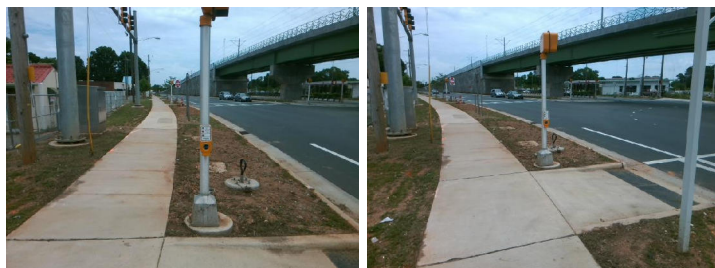
APS Compliance			
Is Button 1 APS or Non-APS?	APS	Is Button 2 APS or Non-APS?	N/A
Yes B 1 VibroTact Arrow?	Yes	N/A B 2 VibroTact Arrow?	N/A
Yes B 1 VibroTact Parallel to Xing?	Yes	N/A B 2 VibroTact Parallel to Xing?	N/A
Yes B 1 VibroTact Contrast	Yes	N/A B 2 VibroTact Contrast	N/A
Yes B 1 Pilot Light?	Yes	N/A B 2 Pilot Light?	N/A
Yes B 1 Pilot Light Illumination?	Yes	N/A B 2 Pilot Light Illumination?	N/A
No B 1 Verbal Walk Cycle?	Yes	N/A B 2 Verbal Walk Cycle?	N/A
N/A B 1 Verbal Message Audible?	Yes	N/A B 2 Verbal Message Audible?	N/A
Yes B 1 Locator Tone?	Yes	N/A B 2 Locator Tone?	N/A
Yes B 1 Percussive Walk Cycle?	Yes	N/A B 2 Percussive Walk Cycle?	N/A
Yes B 1 Extended Press Feature?	Yes	N/A B 2 Extended Press Feature?	N/A
Yes B 1 Tone Audible Range?	Yes	N/A B 2 Tone Audible Range?	N/A

Compliance	Description	Data	Compliance	Description	Data
	Button Count	Button1	N/A	Distant to Additional Button (in)	N/A
	Additional Button Present?	No		Additional Button ID	N/A
N/A	Signal Buttons Required?	N/A	N/A	Additional Ped Posts Required	N/A
	How Many Ped Street Xings?	1		Located In An Island/Median?	No
N/A	B 1 Sign Present?	Yes	N/A	B 2 Sign Present?	N/A
Yes	B 1 Sign Purpose?	Yes	N/A	B 2 Sign Purpose?	N/A
Yes	B 1 Sign Lettering & Contrast?	Yes	N/A	B 2 Sign Lettering & Contrast?	N/A
Yes	B 1 Parallel To XWalk?	Yes	N/A	B 2 Parallel To XWalk?	N/A
Yes	B 1 PAR to Button?	Yes	N/A	B 2 PAR to Button?	N/A
Yes	B 1 PAR to XWalk?	Yes	N/A	B 2 PAR to XWalk?	N/A
Yes	B 1 Clear Floor Space?	Yes	N/A	B 2 Clear Floor Space?	N/A
No	B 1 FWD Approach?	No	N/A	B 2 FWD Approach?	N/A
N/A	B 1 FWD Approach Constrained?	No	N/A	B 2 FWD Approach Constrained?	N/A
N/A	B 1 FWD Approach Reach (in)	16.0	N/A	B 2 FWD Approach Reach (in)	N/A

N/A	B 1 FWD Approach Width (in)	60.0	N/A	B 2 FWD Approach Width (in)	N/A
N/A	B 1 FWD Approach Obstruction?	Yes	N/A	B 2 FWD Approach Obstruction?	N/A
N/A	B 1 FWD Approach Obstruction Dist (in)	13.0	N/A	B 2 FWD Approach ObstructionDist (in)	N/A
No	B 1 PARA Approach?	No	N/A	B 2 PARA Approach?	N/A
N/A	B 1 PARA Approach Constrained?	No	N/A	B 2 PARA Approach Constrained?	N/A
N/A	B 1 PARA Approach Reach (in)	16.0	N/A	B 2 PARA Approach Reach (in)	N/A
N/A	B 1 PARA Approach Width (in)	60.0	N/A	B 2 PARA Approach Width (in)	N/A
N/A	B 1 PARA Approach Obstruction?	Yes	N/A	B 2 PARA Approach Obstruction?	N/A
N/A	B 1 PARA Approach Obstruction Dist (in)	13.0	N/A	B 2 PARA Approach ObstructionDist (in)	N/A
No	B 1 Clear Floor Space Slope (%)	7.6	N/A	B 2 Clear Floor Space Slope (%)	N/A
Yes	B 1 Clear Floor Space XSlope (%)	1.3	N/A	B 2 Clear Floor Space XSlope (%)	N/A
N/A	B 1 PAR Slope (%)	1.1	N/A	B 2 PAR Slope (%)	N/A
Yes	B 1 Height (in)	41.0	N/A	B 2 Height (in)	N/A

Yes	B 1 Pressure (#)	2.0	N/A	B 2 Pressure (#)	N/A
Yes	B 1 Closed Fist Operation?	Yes	N/A	B 2 Closed Fist Operation?	N/A

MUTCD Compliance					
Yes	B 1 Clear Xing Direction?	ClearlyMarked	N/A	B 2 Clear Xing Direction?	N/A
	B 1 Crossing Direction	To SE		B 2 Crossing Direction	N/A
Yes	B 1 DistanceTo XWalk (in)	0.0	N/A	B 2 DistanceTo XWalk (in)	N/A
Yes	B 1 DistanceTo Curb (in)	70.0	N/A	B 2 DistanceTo Curb (in)	N/A
Yes	B 1 Diameter (in)	2.0	N/A	B 2 Diameter (in)	N/A

Possible Solutions: Remove & Replace
Replace APS Button With New APS Button.
Provide Clear Space.
